London Borough of Camden Camden Town Hall Argyle Street Euston Road London WC1H 8EQ Your Ref: 2016/1117/P Our DTS Ref: 26941

Re: BANGOR WHARF, GEORGIANA STREET, LONDON, NW1 0QS

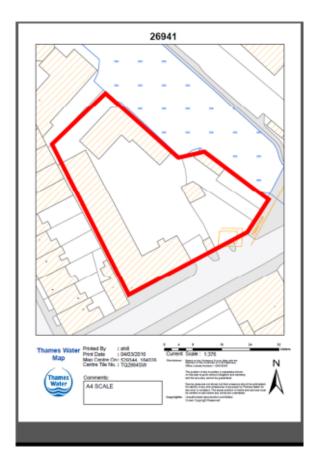
In the South East of the proposed development there are easements and wayleaves running throughout the site. These are Thames Water Assets. The company will seek assurances that it will not be affected by the proposed development. On the Map yellow dashed lines show the easements and wayleaves and the proposed development area is identified by a red outlined box.
